REV	BY	DATE	DESCRIPTION
1	THC	08/17/07	REVISED WALL DESIGN

WILKINSON COMMONS  
LA JOLLA POINTE DRIVE AND I-30  
ROCKWALL, TEXAS  
RETAINING WALLS

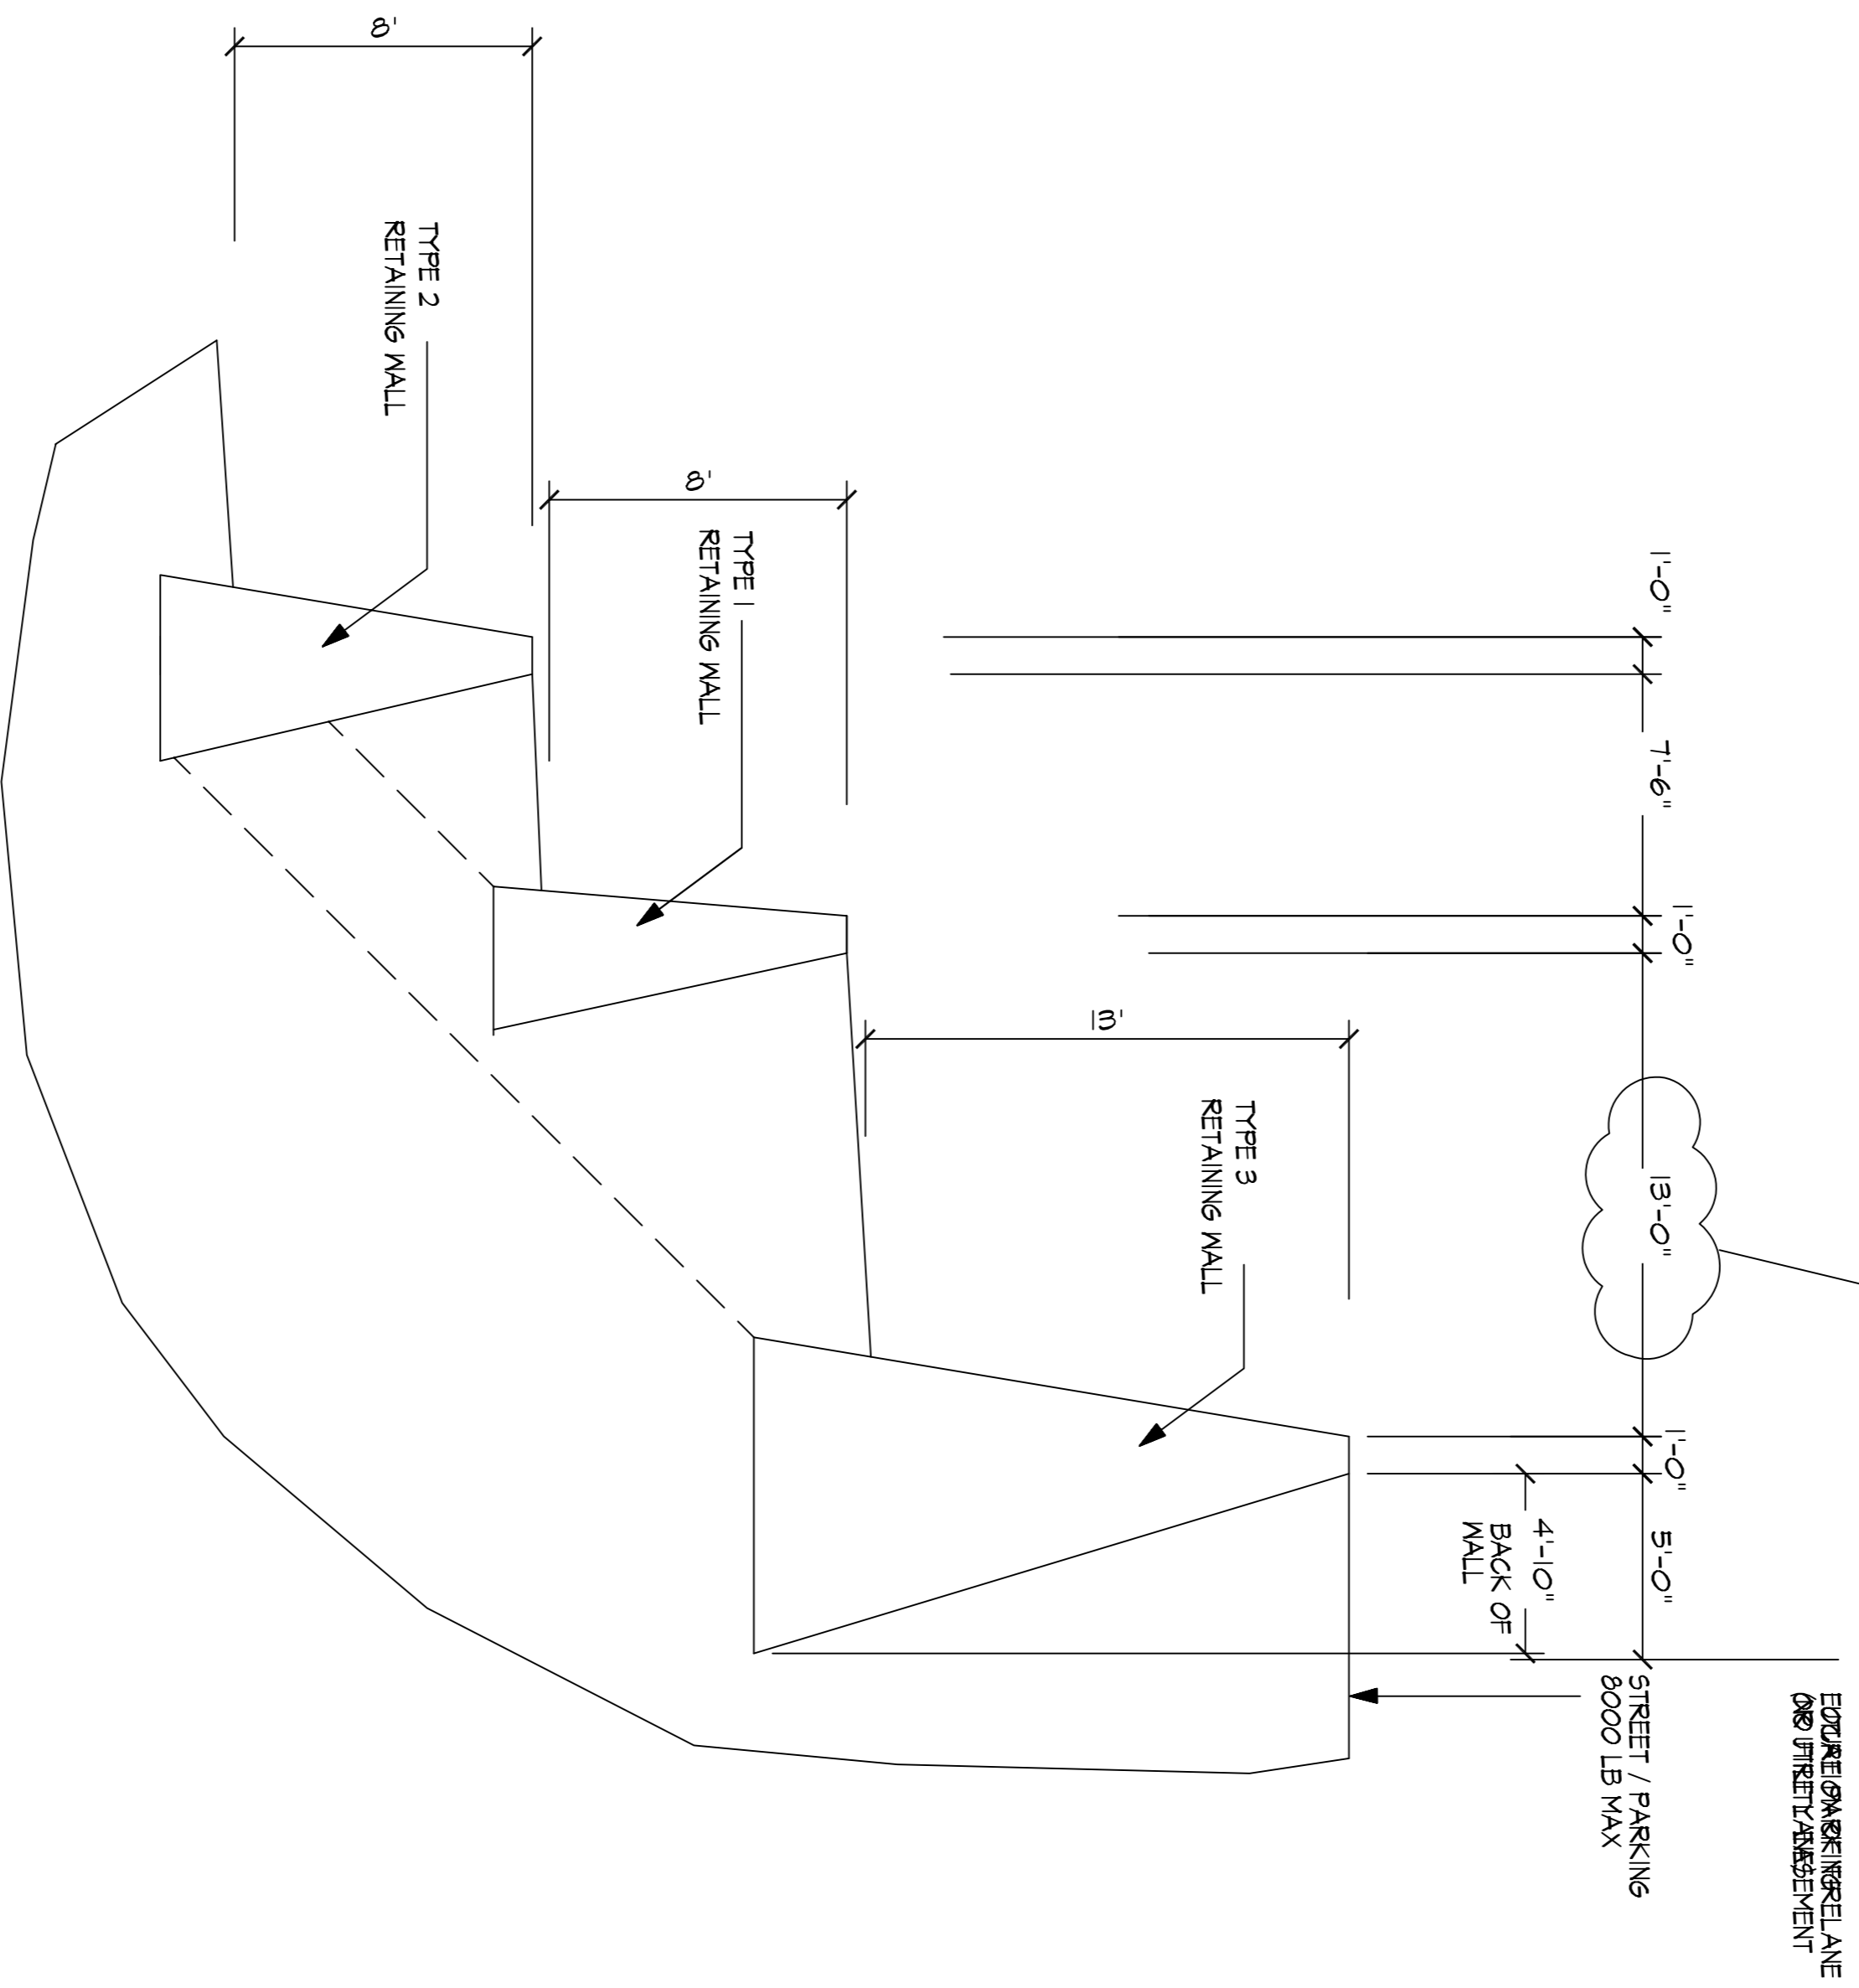
LOCATION OF WALL HAS BEEN MOVED FROM 11' TO 13' AS DISCUSSED WITH THE CIVIL ENGINEER. VERIFICATION REQUIRED BEFORE INSTALLATION.
